NSW National Parks and Wildlife Service

Your ref: SSD-21342738
Our ref: DOC26/71406

Thank you for notifying the NSW National Parks and Wildlife Service (NPWS) of the modification to state significant development SSD-21342738, being for the Expansion of DCI's Eastern Creek Data Centre, located at 90 Peter Brock Drive Eastern Creek.

Attachment A

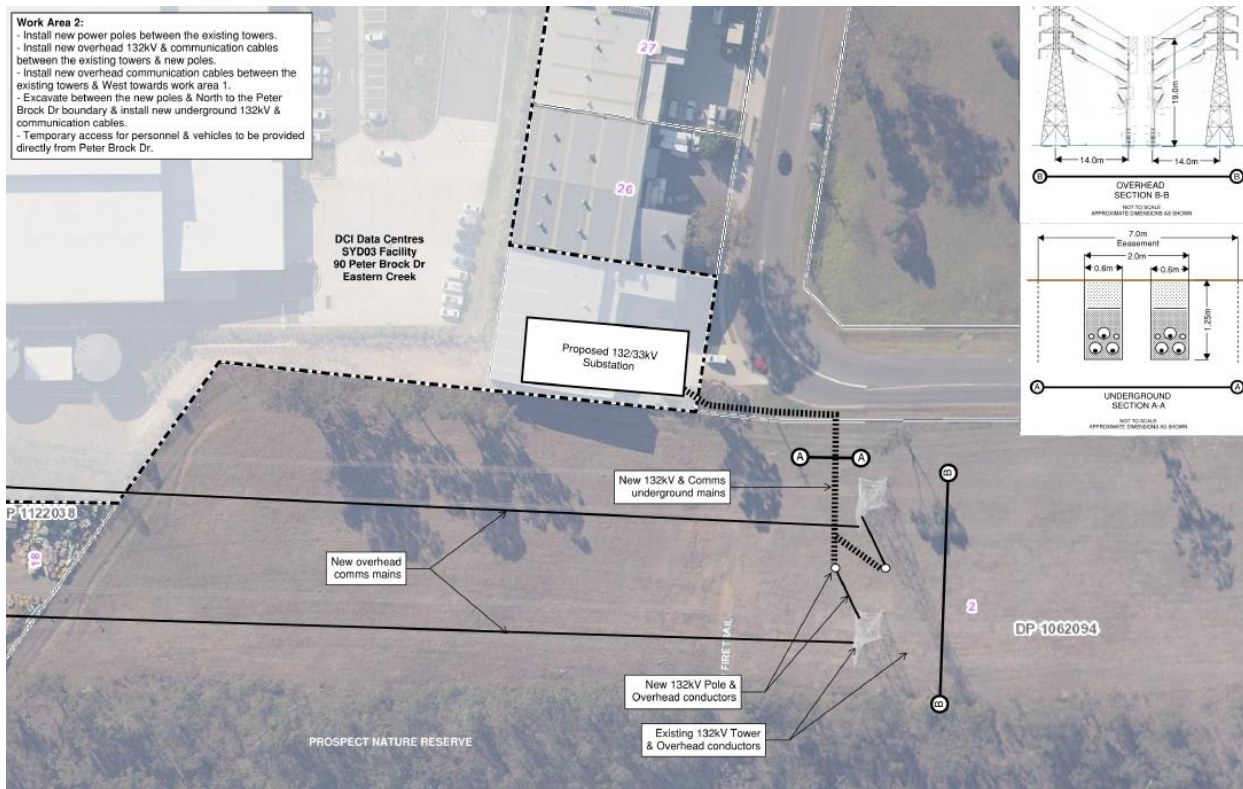
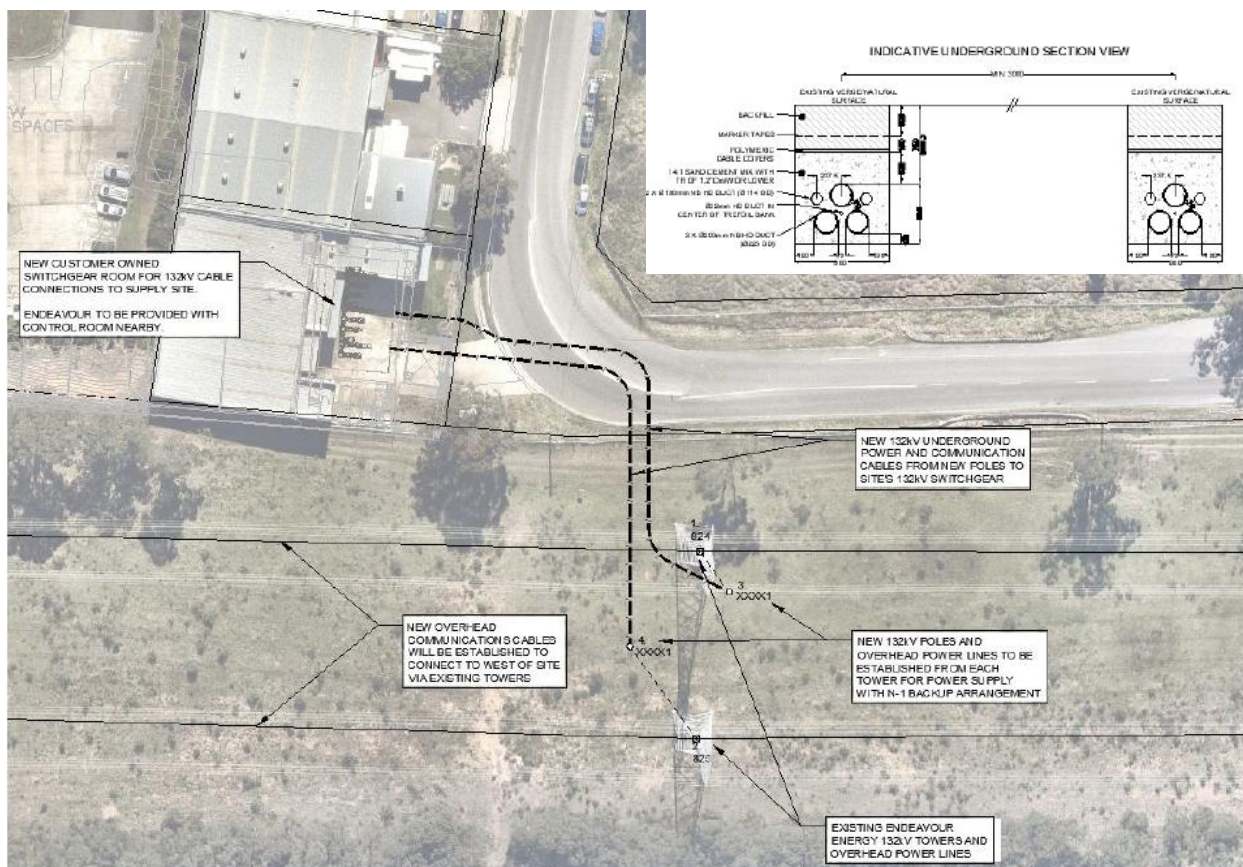
- It is unclear from *Appendix E – Infrastructure Servicing Strategy* whether the works associated with this electrical connection will require changes due to the increased power consumption of the site and/or changes to the substation. Some differences in alignment and separation of the underground cabling with the approved works have been noted in Figure 4 of the Infrastructure Servicing Strategy. See the excerpts of relevant diagrams in **Attachment A** to this letter.

Electrical connection approved by NPWS (note: 2-metre separation of buried cable bundles)

Indicative electricity servicing strategy (note: minimum 3-metre separation and different alignment)

- Any changes to the approved electrical connection works would be subject to a modification to the NPWS authorisation, and consideration of additional impacts through an addendum to the determined REF.

- **NPWS recommends:**
 - Further information is provided on the implications of the proposed modification on ancillary services, such as the electrical connection through Prospect Nature Reserve to the Endeavour Energy transmission line.
